**ADDENDUM #2**

<b>Project</b>	TA Blakelock High School Renovations	<b>Project No.</b>	2215-C
<b>Location</b>	1160 Rebecca Street, Oakville, ON	<b>Date of Issue</b>	2025 04 25
<b>Owner</b>	Halton District School Board	<b>File</b>	2215/7.1.3

This Addendum forms part of the Contract Documents and amends the original Drawings and Specifications, dated 2025 04 17, and all preceding Addenda, as noted below.

8 WINDOW SILL DETAIL @ MEATL WALL PANEL  
A107 1:5

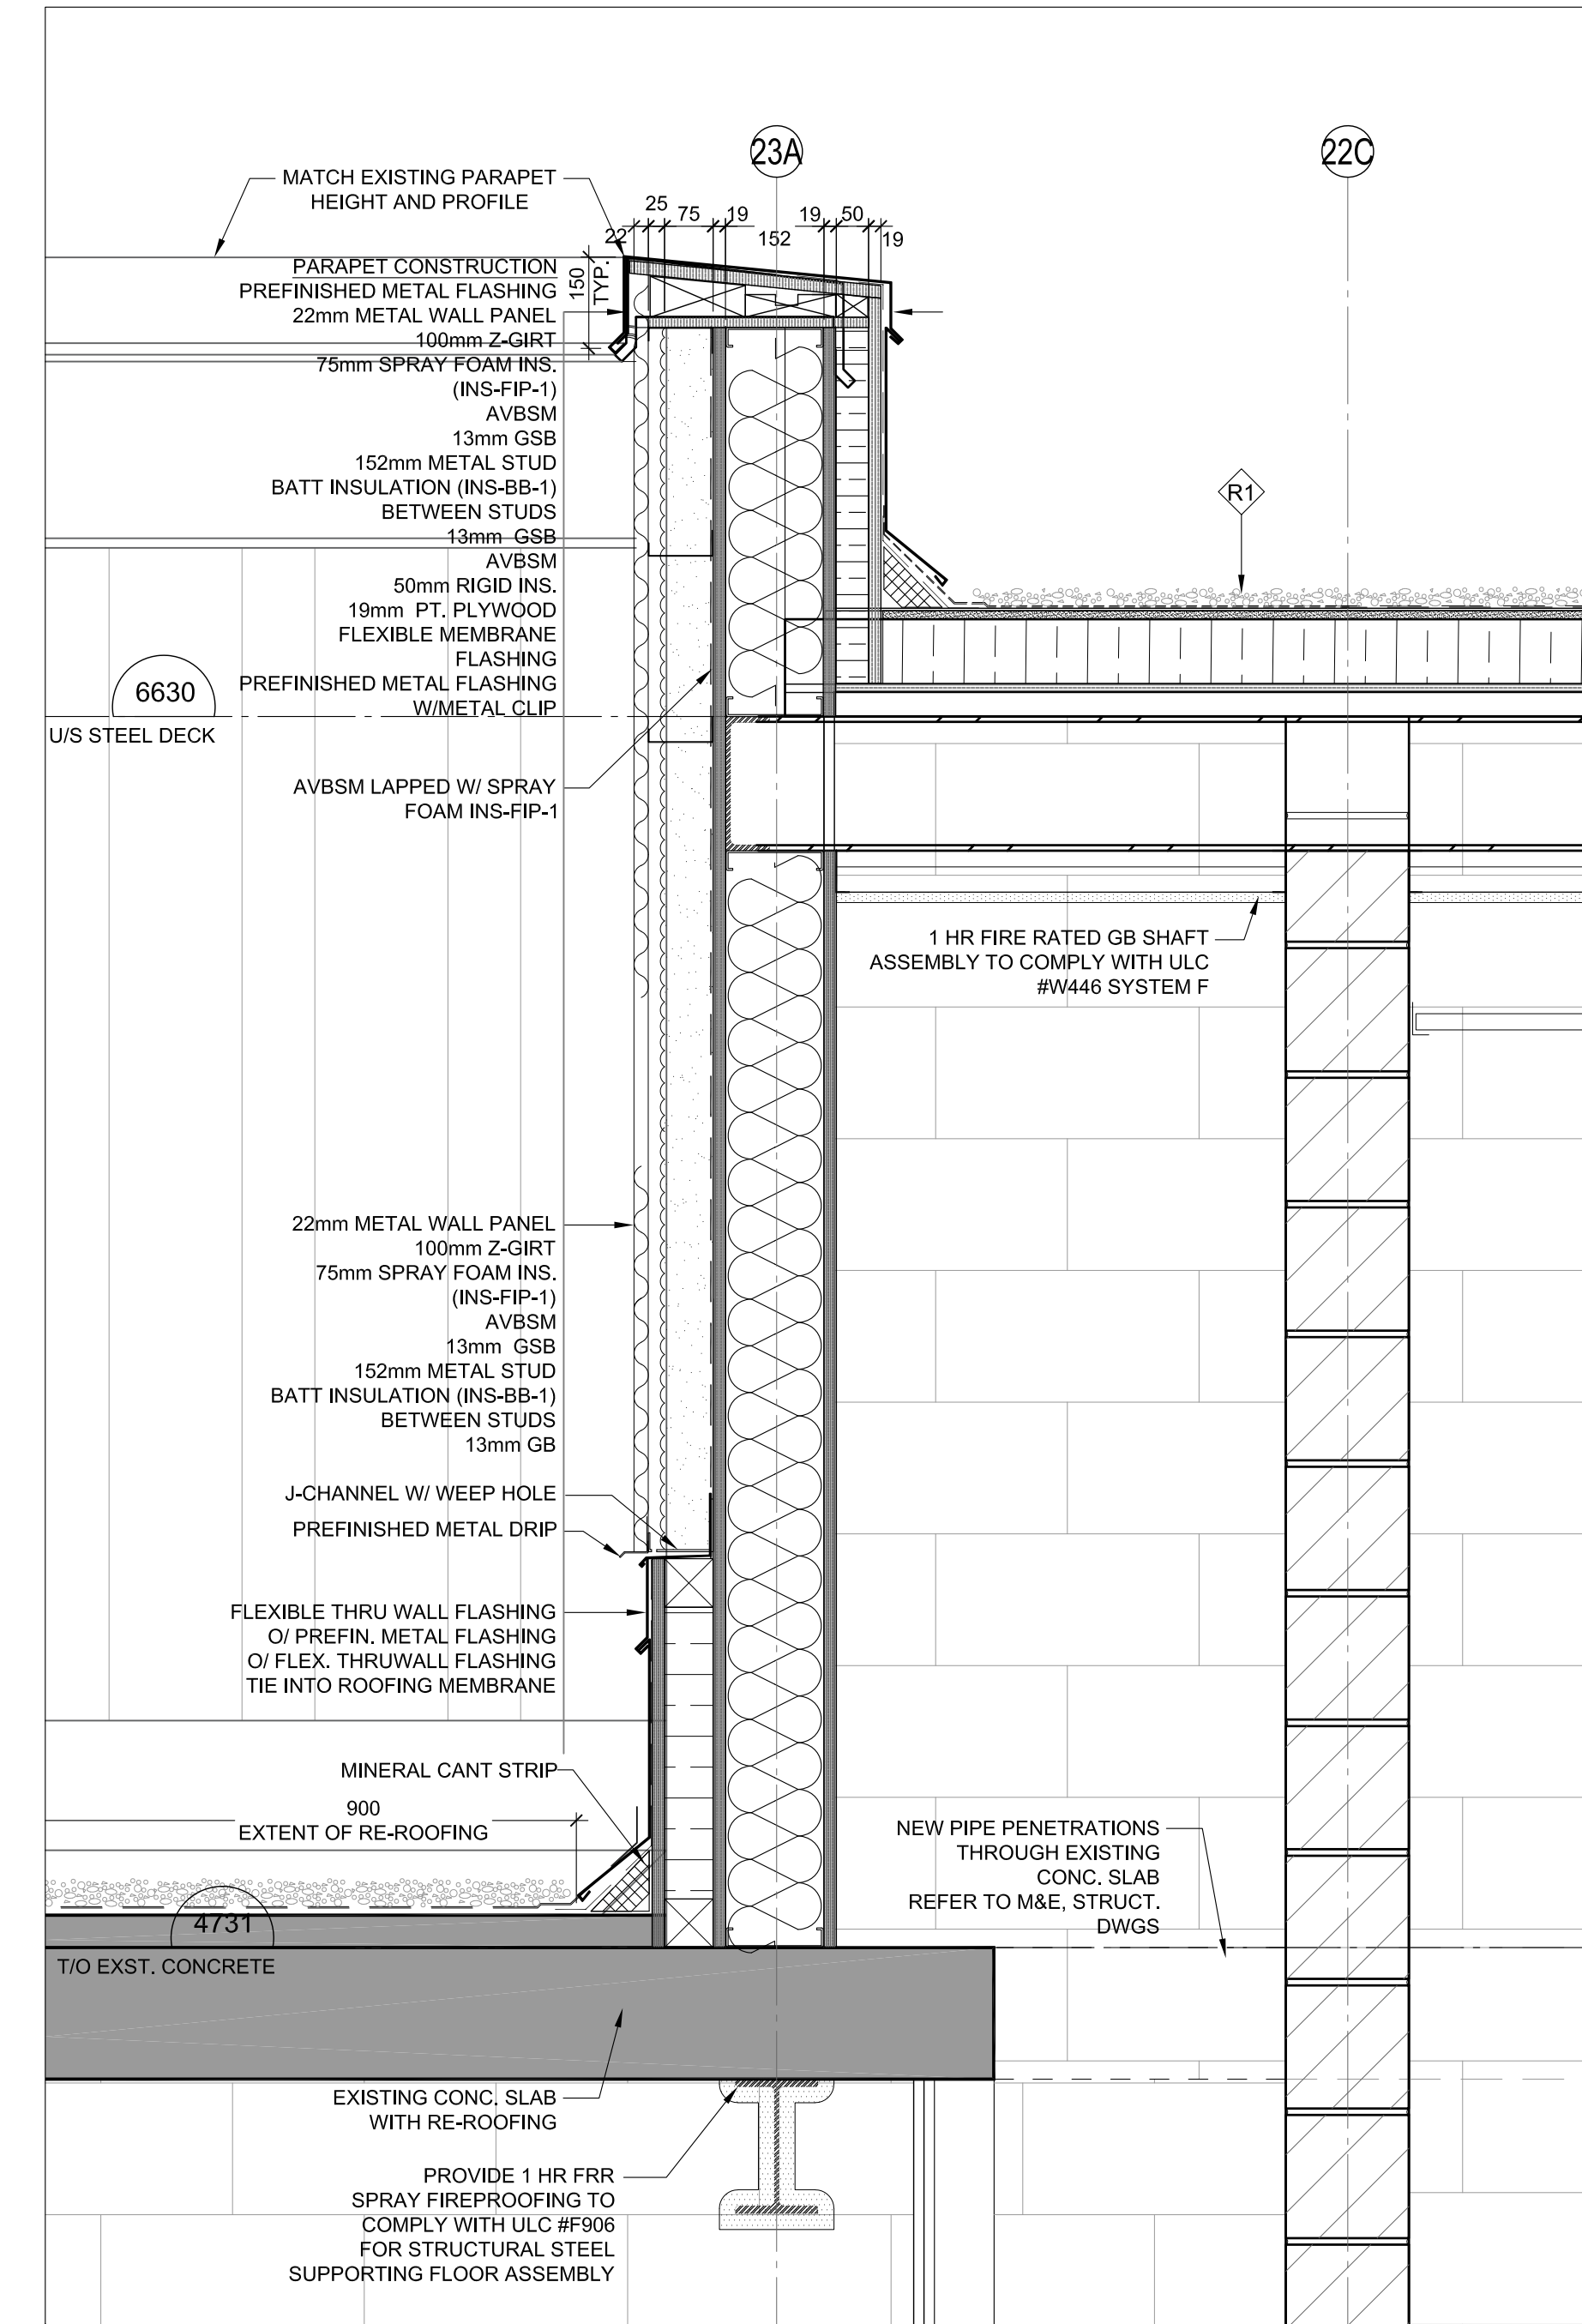
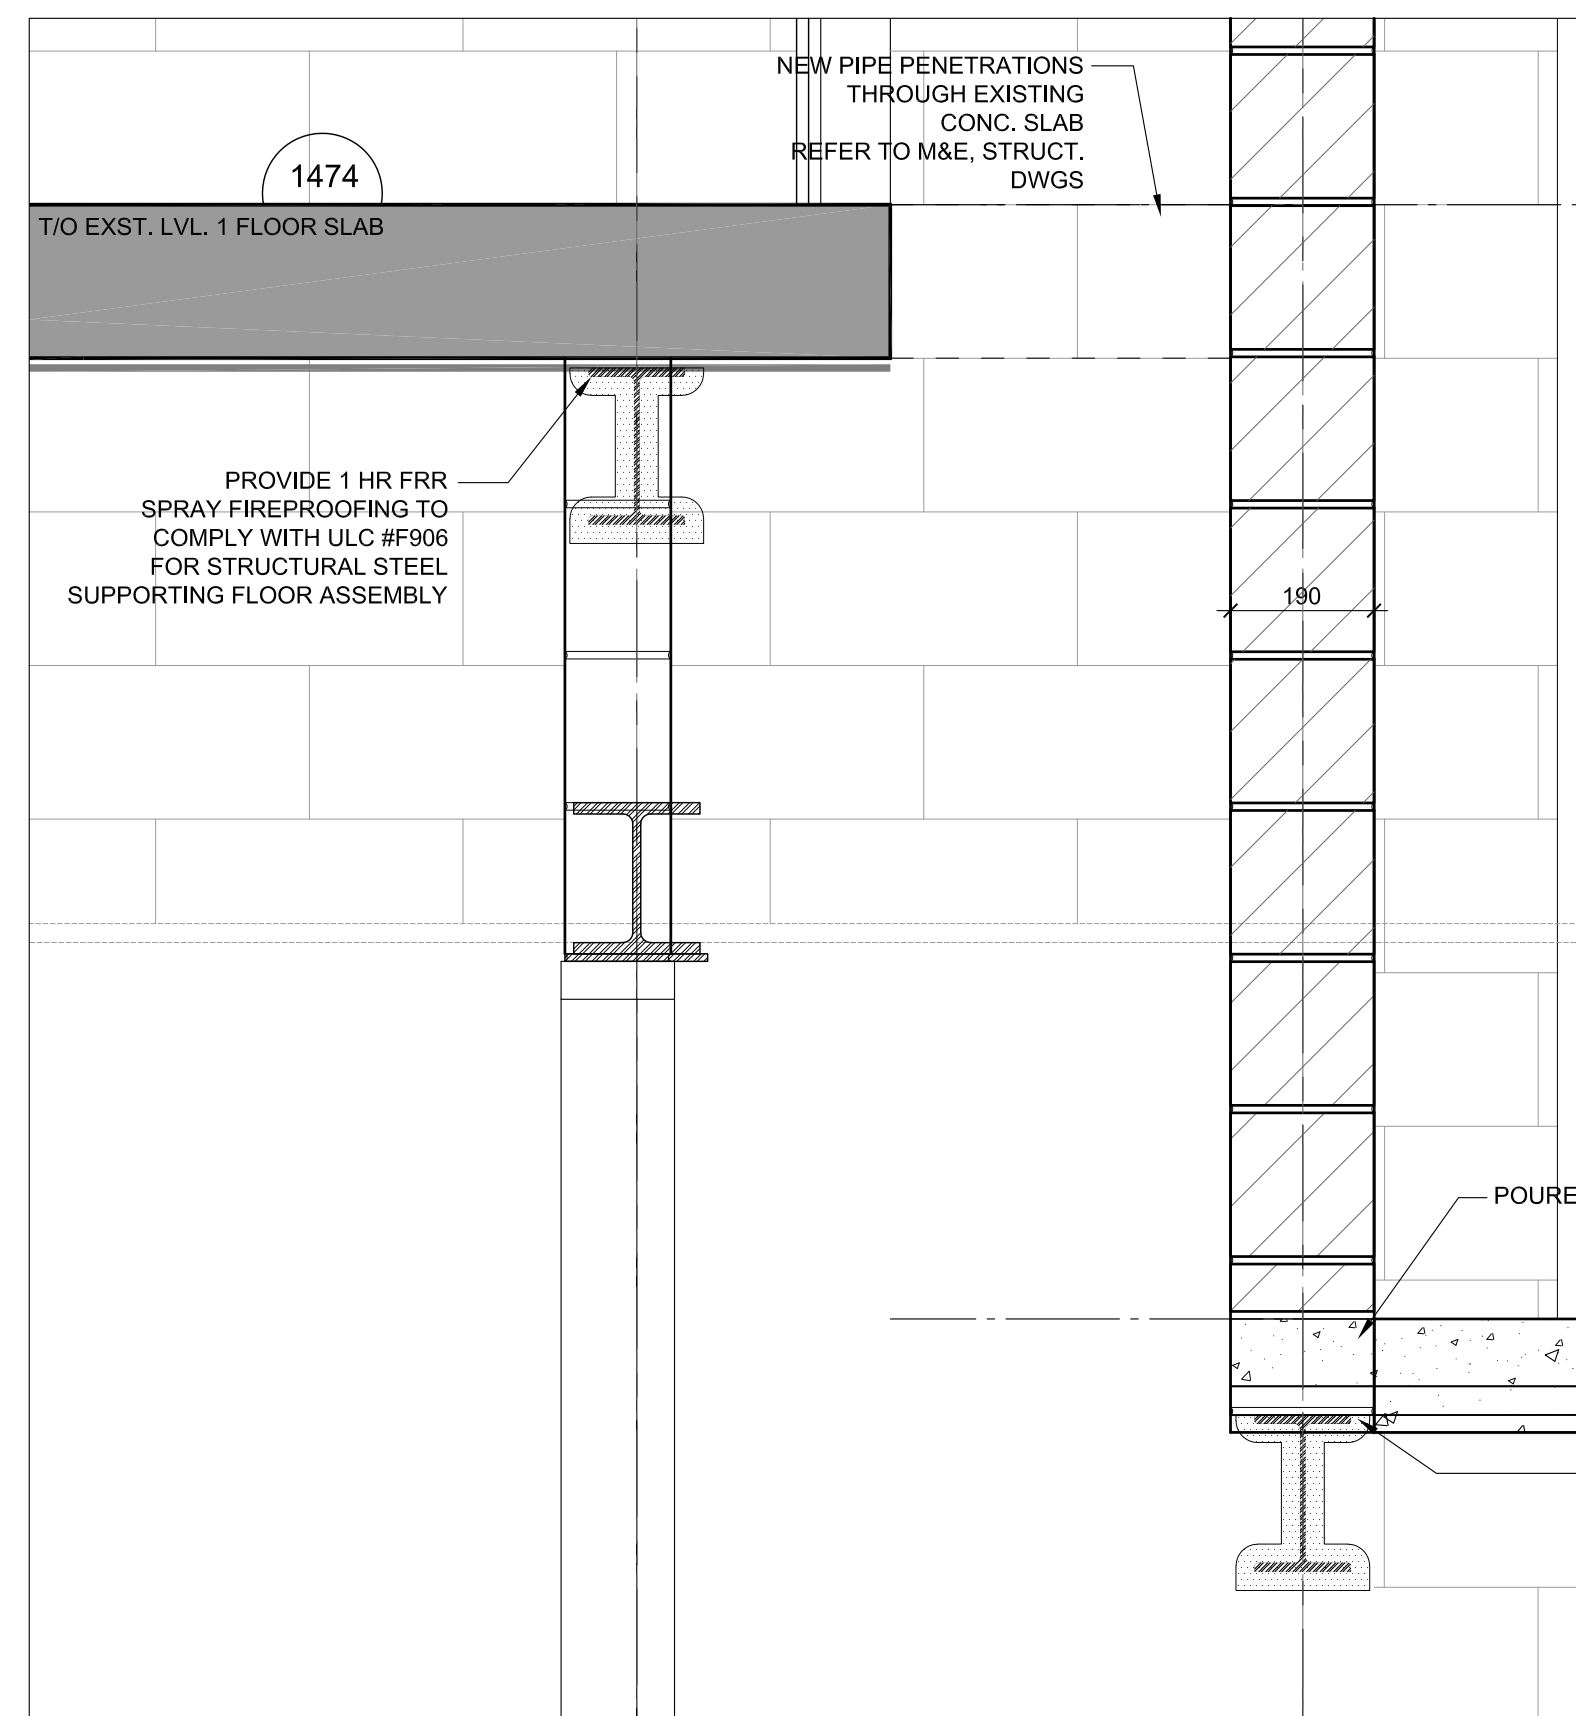
- .1 New drawing added for section details and typical details.
